CS Memorandum No. 1444

Subject: Configuration Management Board Meeting No. 125

CMB Meeting Minutes #125

SUBJECT: Configuration Management Board Meeting # 125 – Rev. No. 0

Field sketch No. 125
COR 079

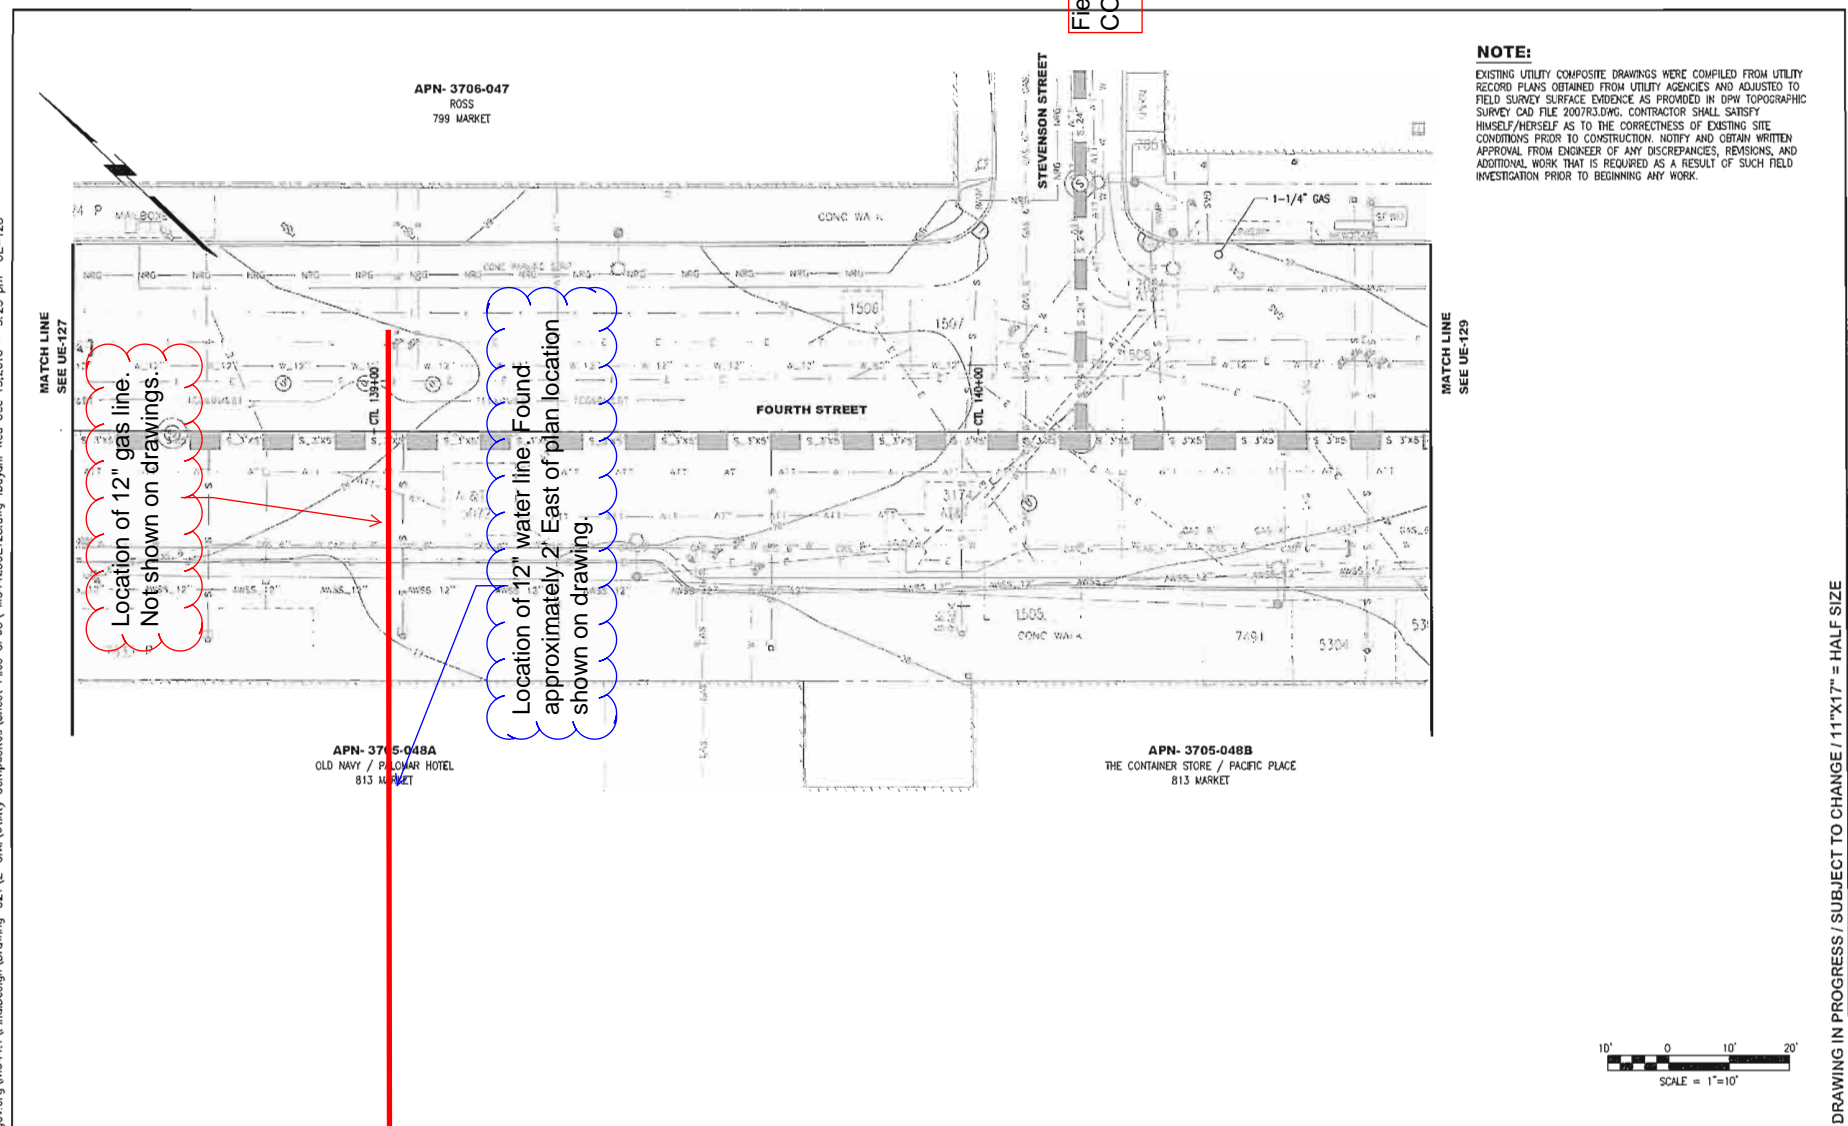
Location of 12" gas line.
Not shown on drawings.

Location of 12" water line. Found
approximately 2' East of plan location
shown on drawing.

DRAWING NO. CS 1252 - 031
COR 076

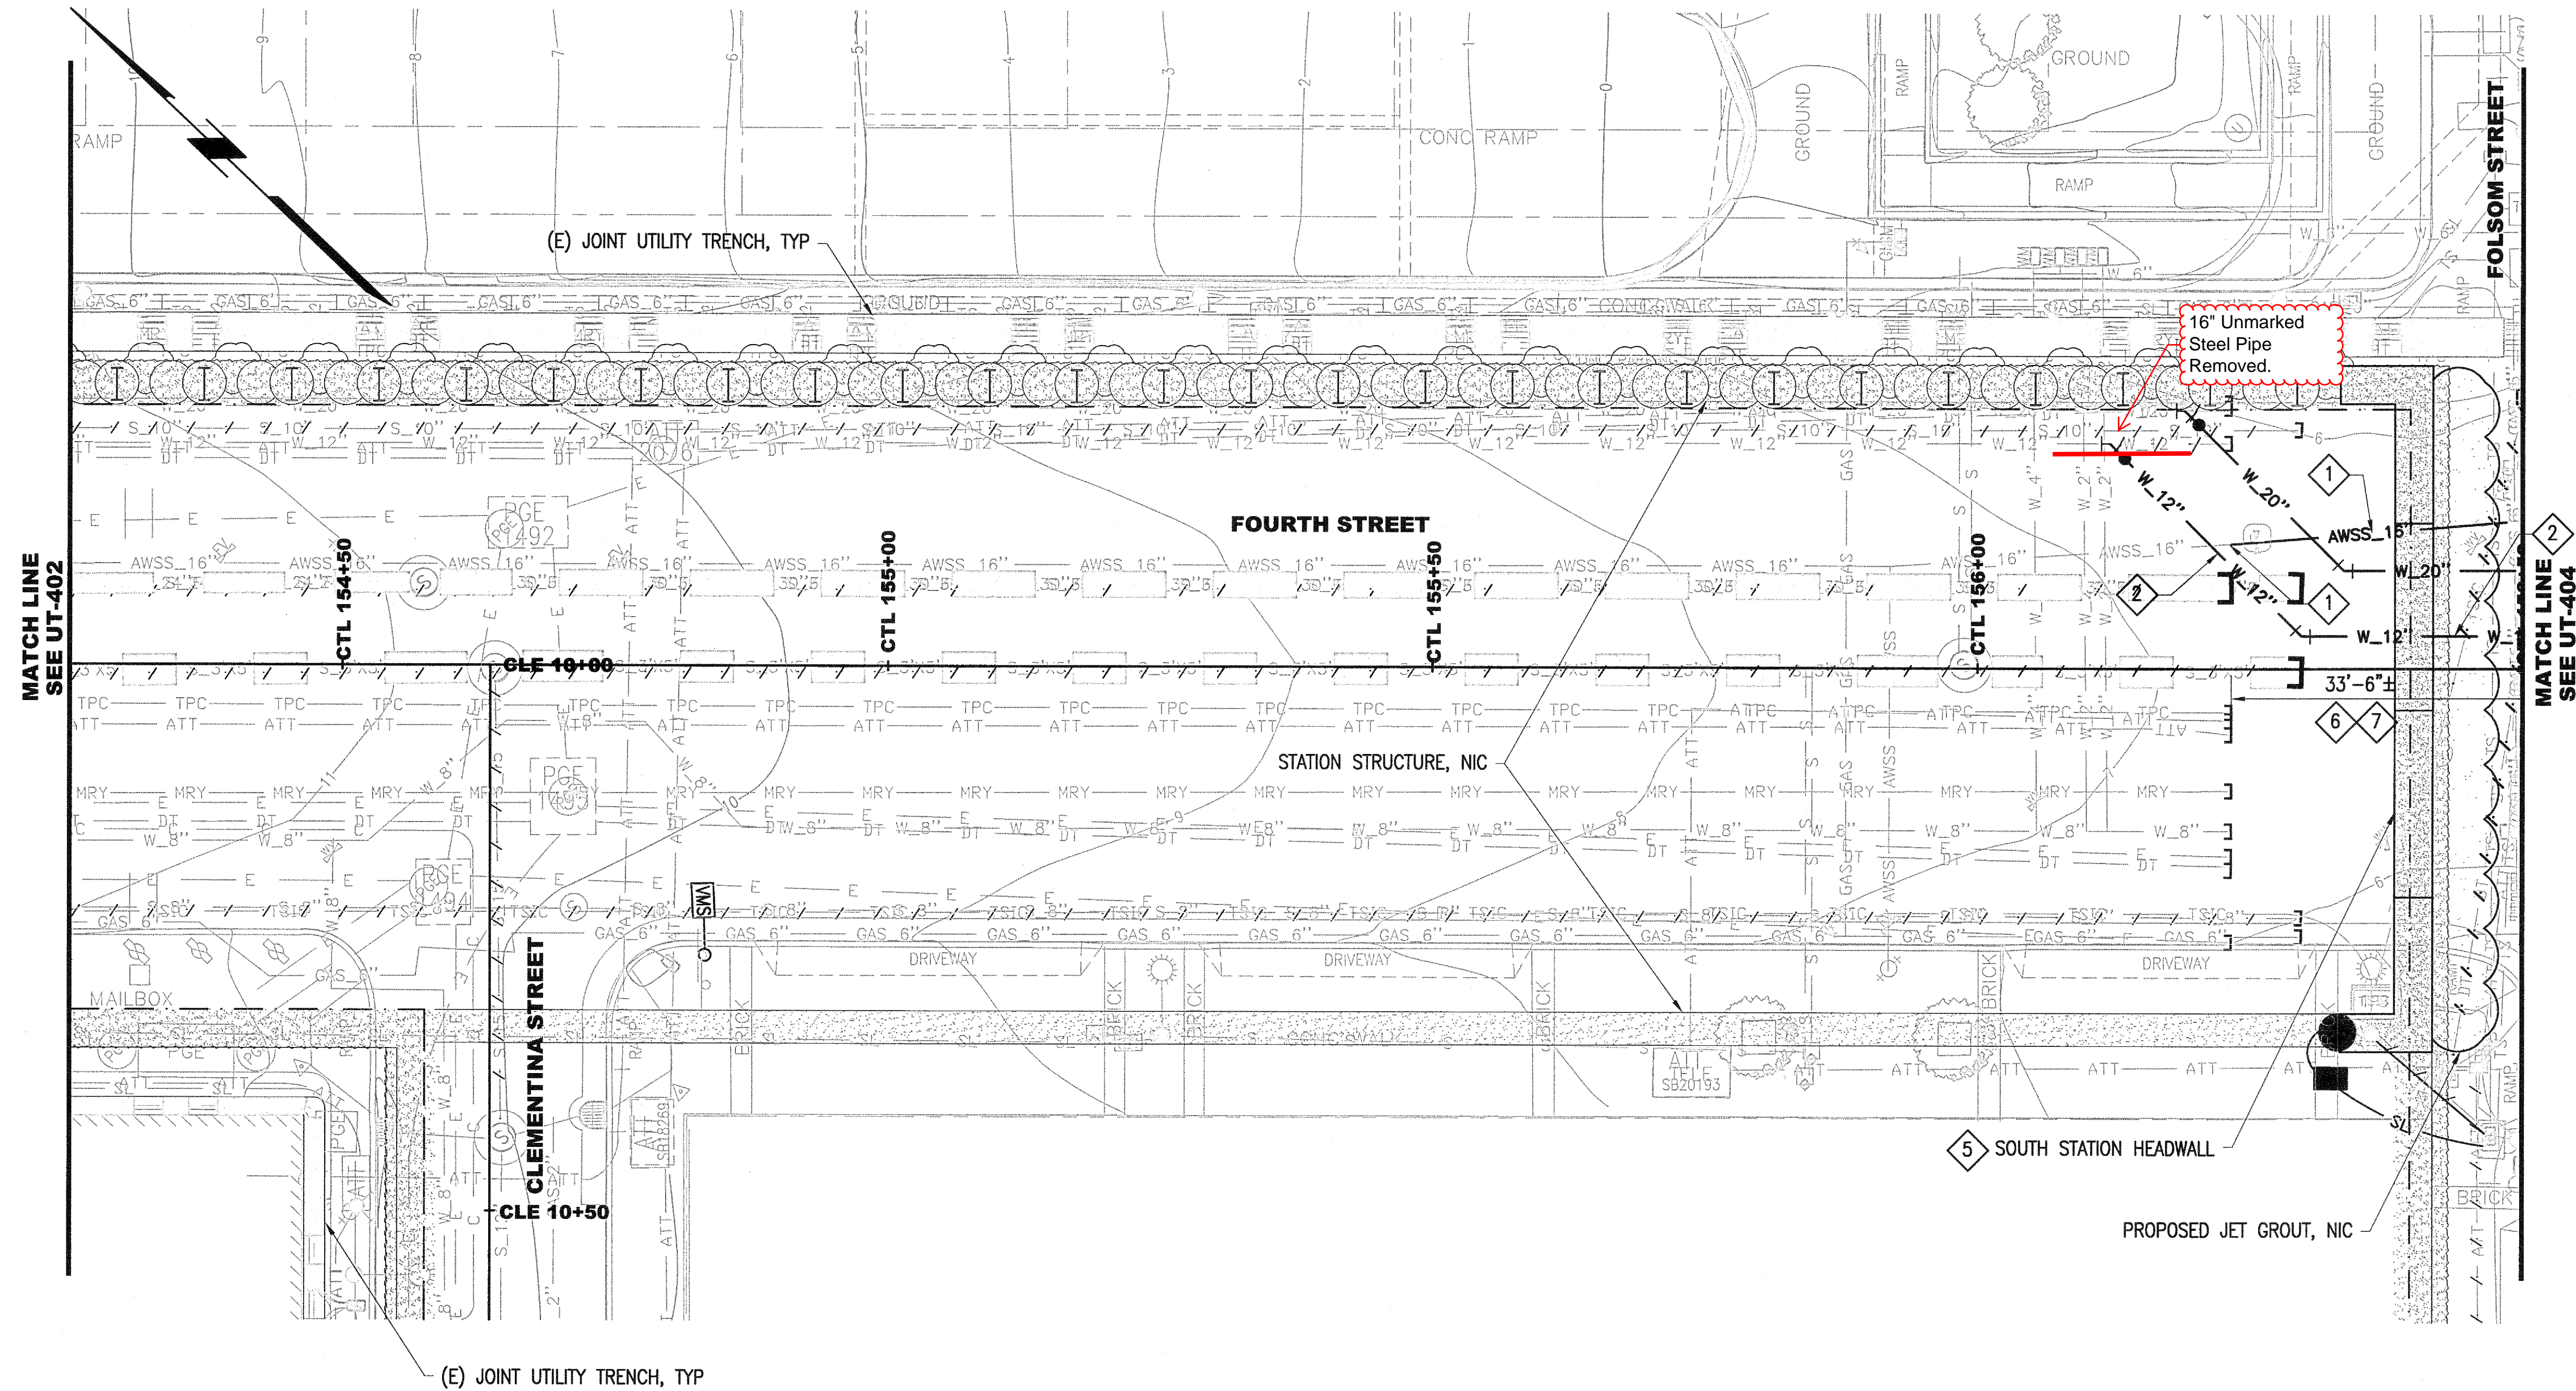
Facts: The Contractor encountered an abandoned 16" pipe located in the trench of the proposed 12" low pressure waterline. The 12" waterline could not be installed until the abandoned 16" pipe was removed. The 16" steel pipe was removed at the 12" water tie-in location at the north side of the Moscone southeast headwall. See attached Drawing CS 1252 - 31.

Justification: The contract drawings, specifically WD-403 rev.0 and UD-403 rev.0, did not show the abandoned 16" pipe which constitutes a differing and unforeseen site condition. The 16" pipe was at the same elevation as the proposed 12" waterline and therefore needed to be removed. SFTMA inspectors have verified that additional labor and equipment resources were required to facilitate removal of the 16" abandoned pipe.

**DRAWING NO. CS 1252 - 021
COR 073**

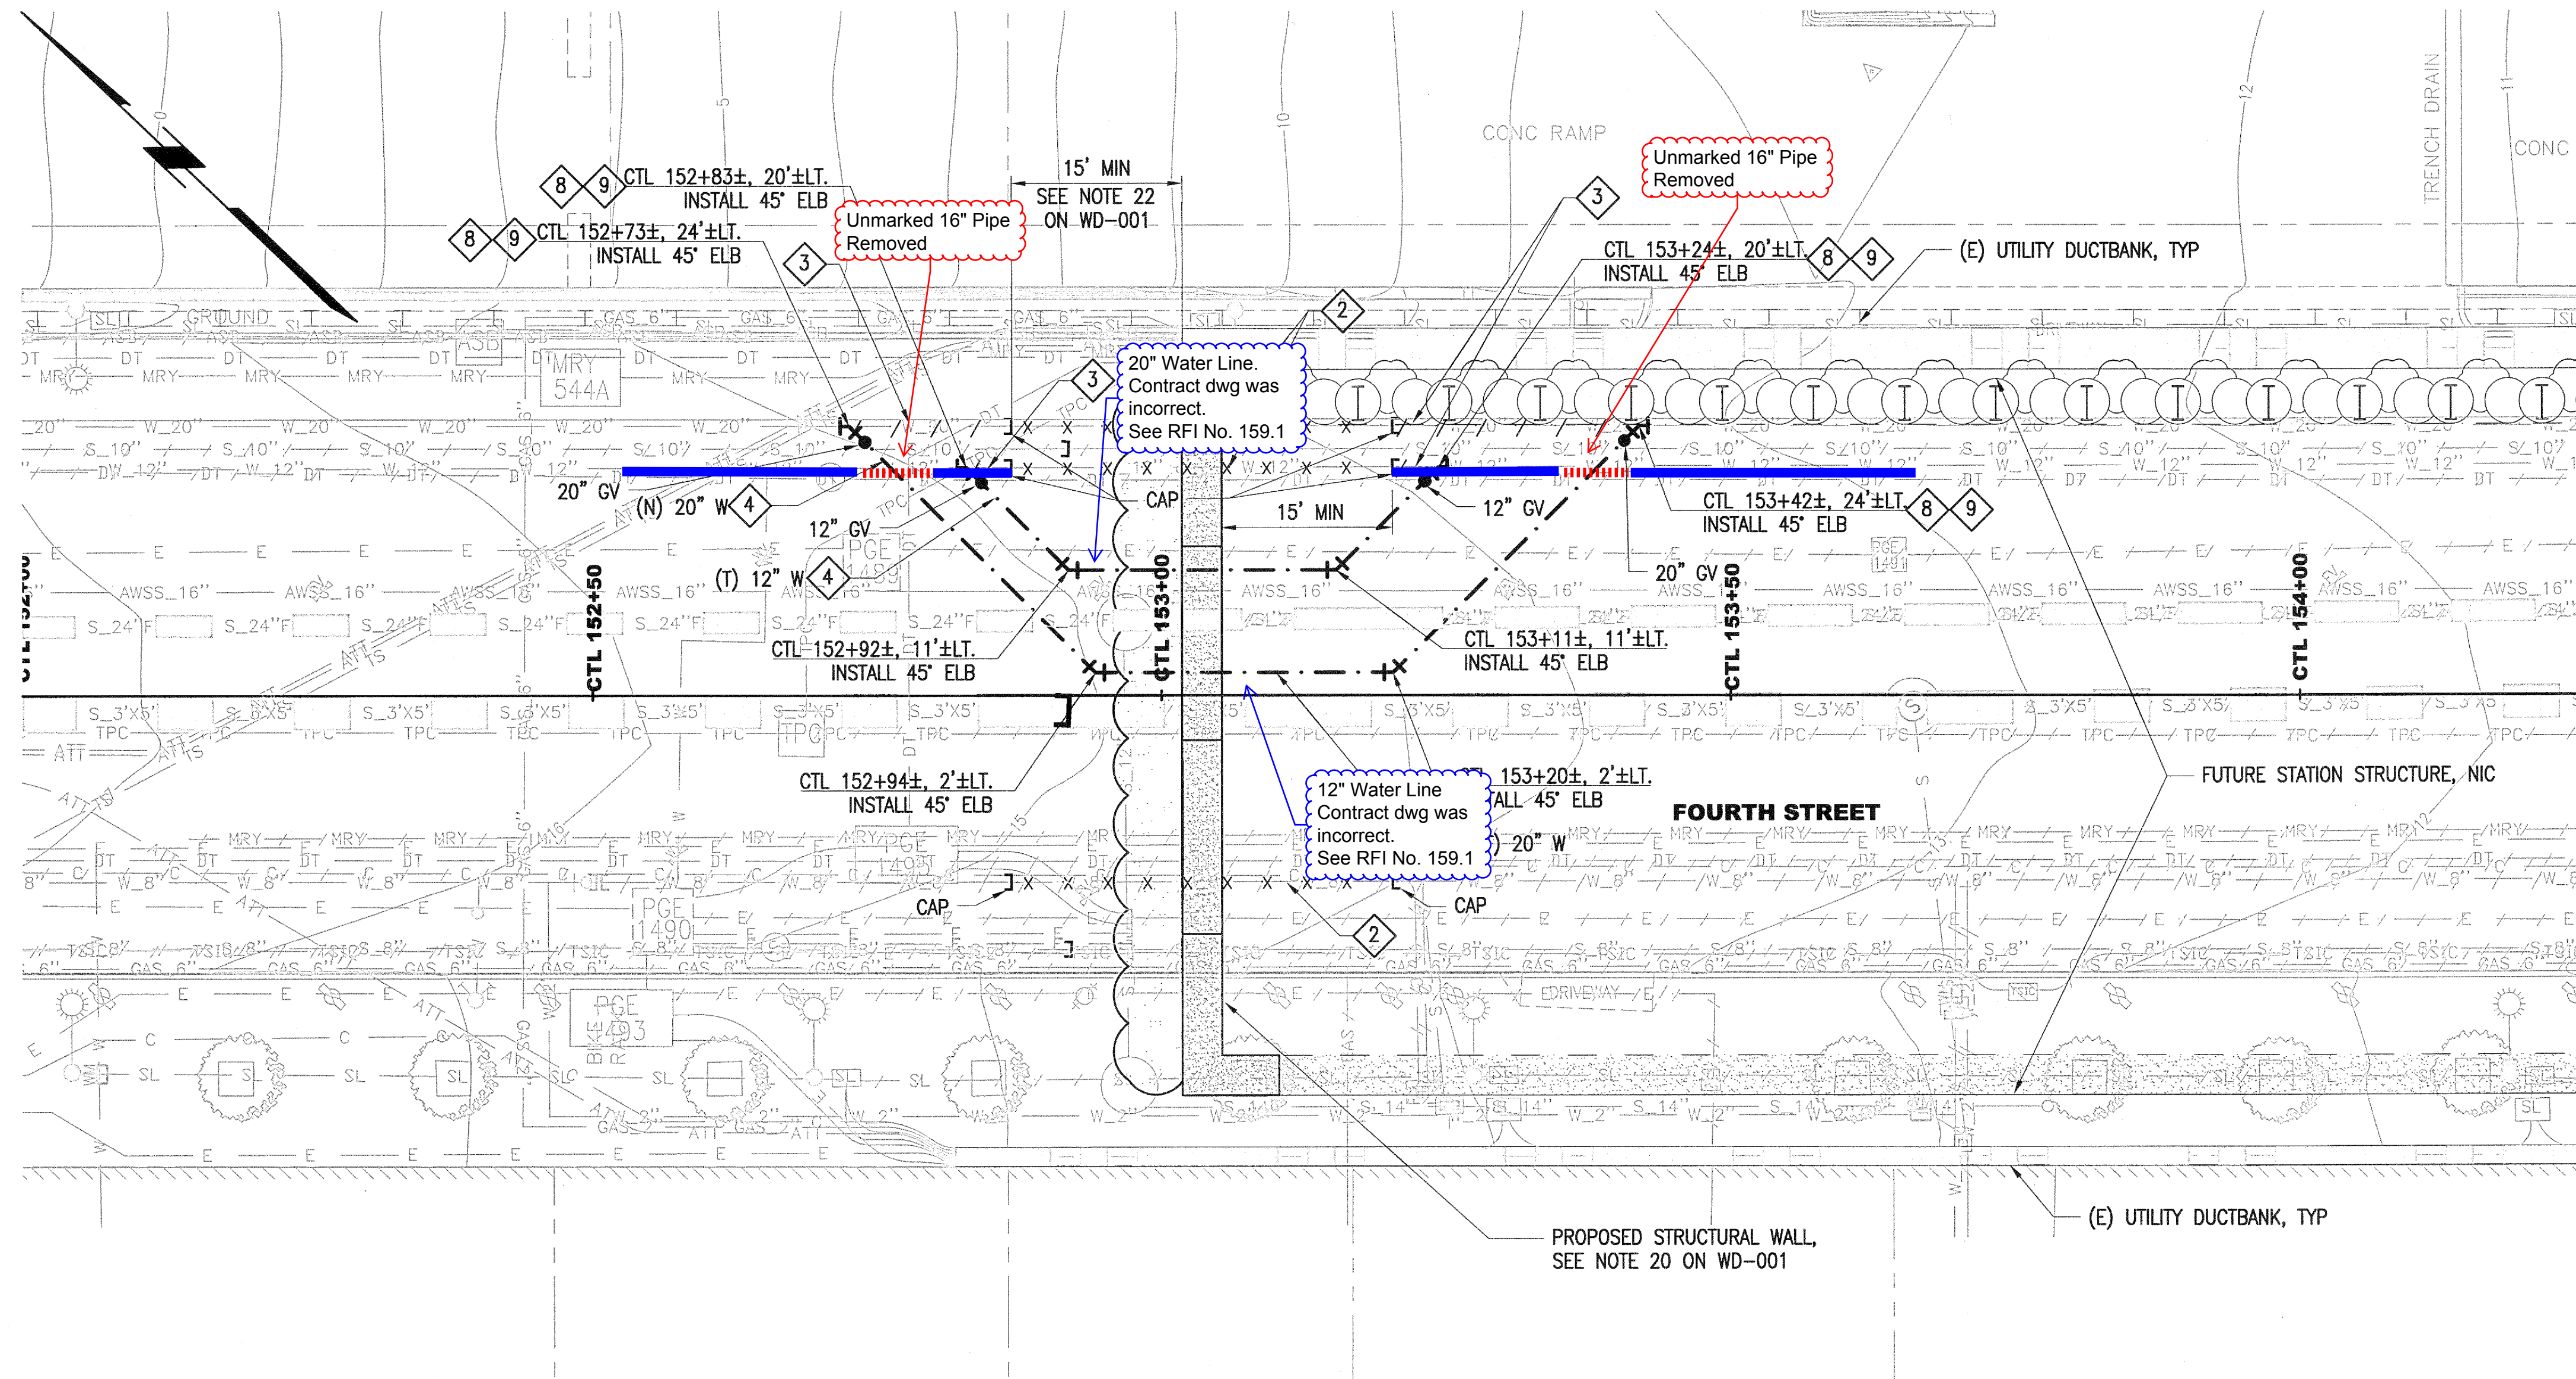
Facts: On February 14th, 2013 the Contractor encountered an abandoned 16" pipe located in the trench of the proposed 12" low pressure waterline. The 12" waterline could not be installed until the abandoned 16" pipe was removed. The 16" steel pipe was removed at the 12" water tie-in locations at the north and south side of the Moscone northeast headwall. See attached Drawing CS 1252 - 21.

Justification: The contract drawings, specifically WD-402 rev.0 and UD-402 rev.0, did not show the abandoned 16" pipe which constitutes a differing and unforeseen site condition. The 16" pipe was at the same elevation as the proposed 12" waterline and therefore needed to be removed. SFTMA inspectors have verified that additional labor and equipment resources were required to facilitate removal of the 16" abandoned pipe.

Photo 3. Example of gasket offset of 3/8" (10mm)

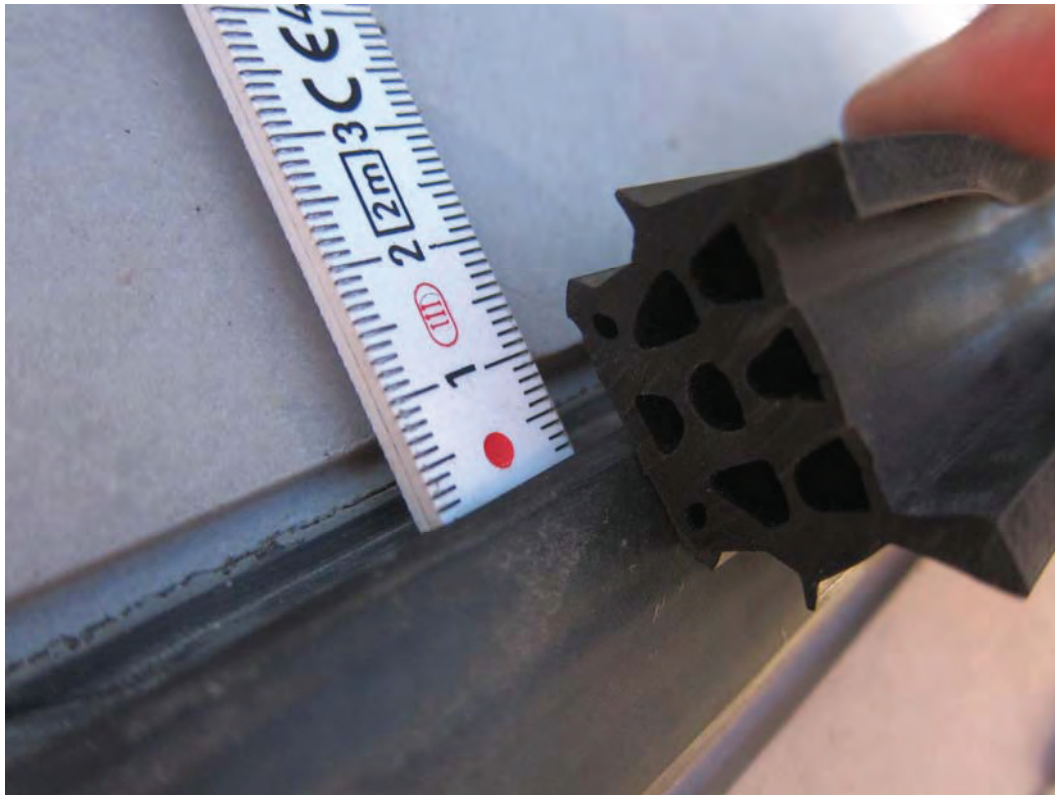
- Segment Bearing:
 - Along the circumferential faces the spalling results in a minor reduction of bearing area used to resist the forward thrust of the TBMs, along the radial faces this spalling will affect the ability of the segments to resist birdsmoothing and bursting. Based on a review of our calculations for the segmental liner, substantially more area would have to be removed from the segments in order for this to be of concern. To provide clarity in repair requirements, the following guidelines are provided for the need to repair spalling in terms of bearing performance:
 - Repairs are not required if:
 - The spall is no deeper than 0.1 inches (2.6mm), that is, the depth of the stress relief;
